**ADDENDUM 3 TO BID DOCUMENTS FOR THE
BAYOU CANE MARSH CREATION PROJECT
(PO-0181)**

ST. TAMMANY PARISH, LOUISIANA

**STATE OF LOUISIANA
COASTAL PROTECTION AND RESTORATION AUTHORITY**

July 25, 2025

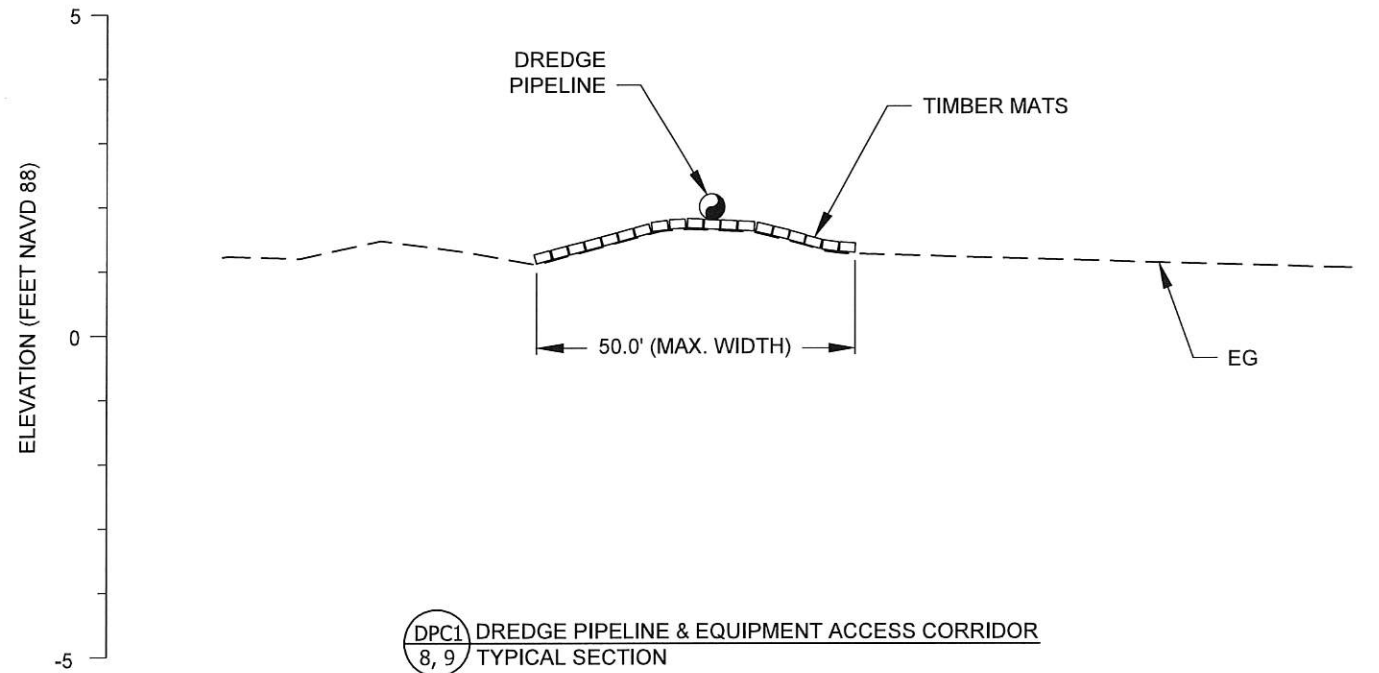
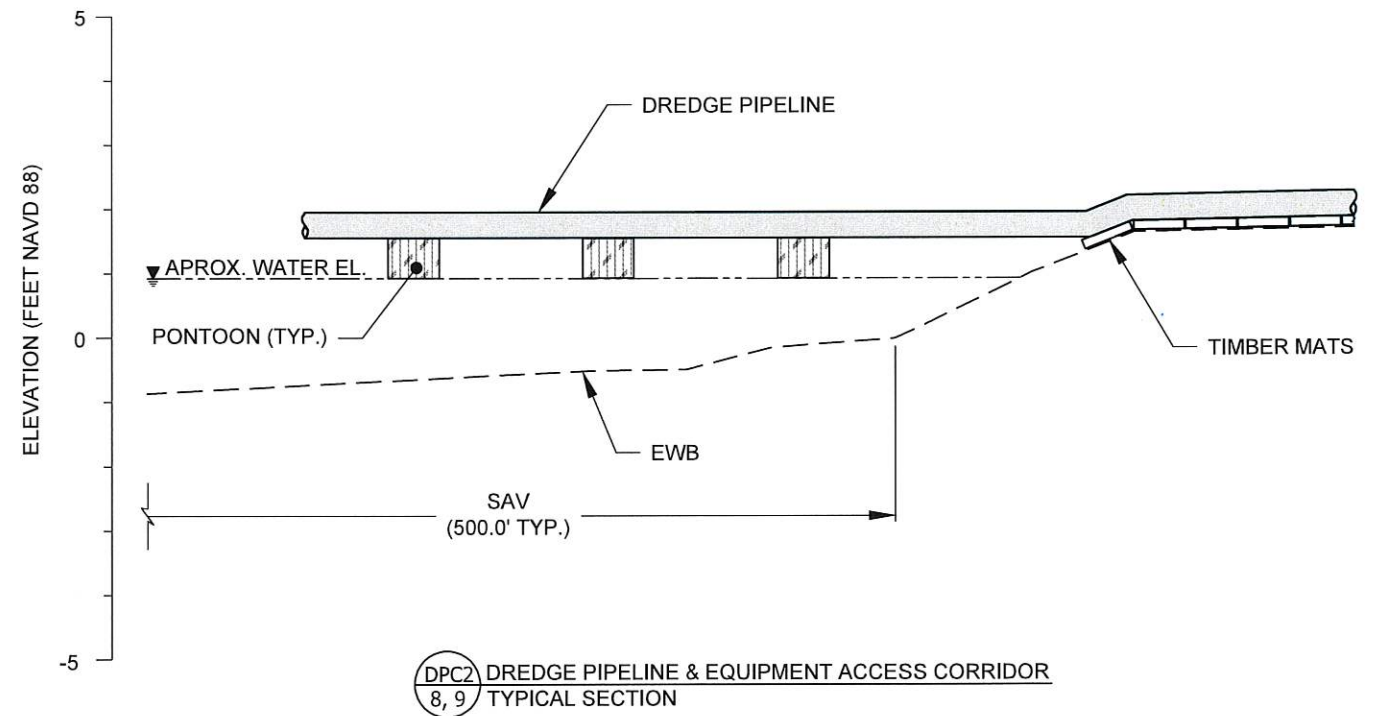
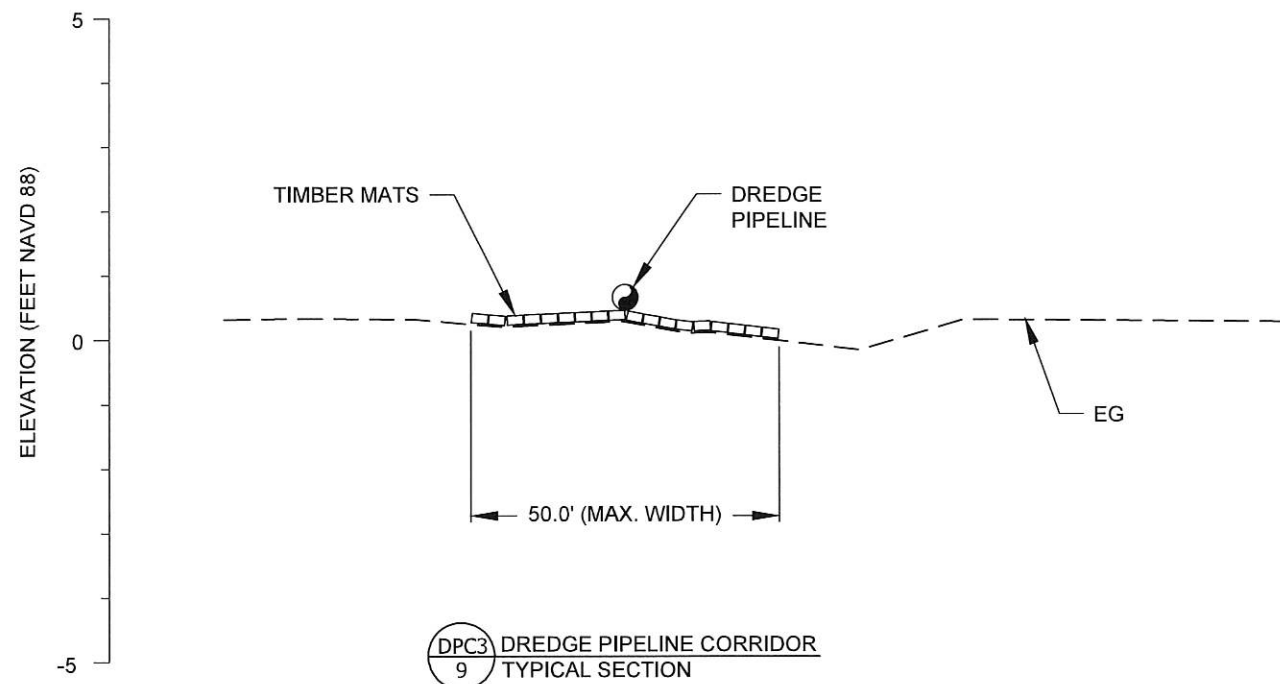
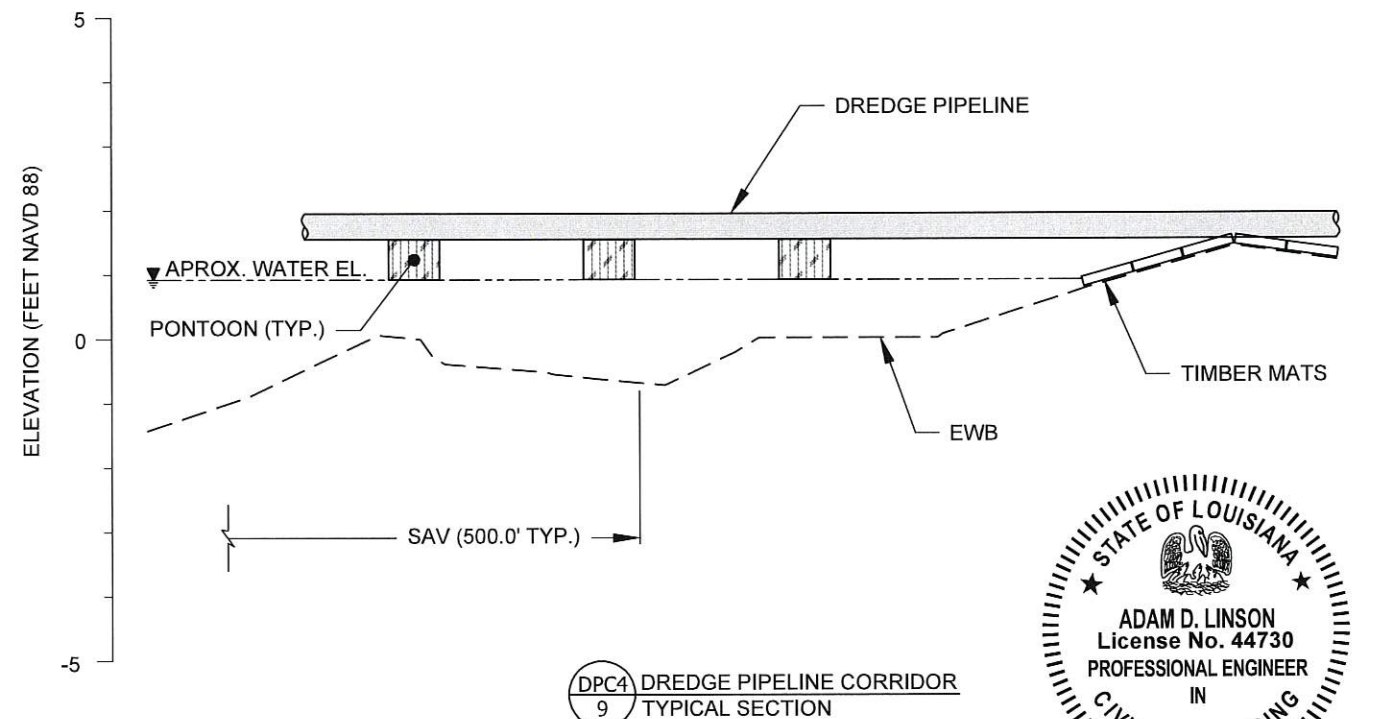
Plan Sheets 5, 6, 7, 8, 9, and 16: A Modification to Note 1 and the note pertaining to Section DPC2 and DPC4 (Sheet 16), is represented by bold, italicized text, and is replaced in its entirety with the following:

NOTE:
TIMBER MATS SHALL BE PLACED WHEN THE DREDGE PIPELINE OR THE EQUIPMENT ACCESS CORRIDOR CROSSES OVER THE EXISTING SHORELINE OR MARSH.

NOTE:
THE DREDGE PIPELINE SHALL BE FLOATED FROM THE SHORELINE OF LAKE PONCHARTRAIN TO A MINIMUM DISTANCE OF FIVE HUNDRED FEET (500.0') FROM THE SHORELINE TO AVOID IMPACTS TO EXISTING SUBMERGED AQUATIC VEGETATION (SAV). TO THE GREATEST EXTENT POSSIBLE, EQUIPMENT SHALL REMAIN FLOATING AT ALL TIMES IN AREAS WHERE SAV IS PRESENT.

NOTE:
TIMBER MATS SHALL BE PLACED WHEN THE DREDGE PIPELINE CROSSES OVER THE EXISTING SHORELINE OR MARSH.
